SUBJECT: REQUEST FOR THE RENEWAL OF MATERIALS LICENSE NO. 54-28275-02MD

Please find enclosed our replies to your request for additional information made on March 12, 2015.

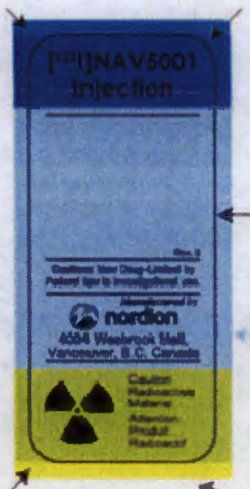
2) Provide a sample of the NAV5001 (I-123) vial label:

A sample is hereby provided.
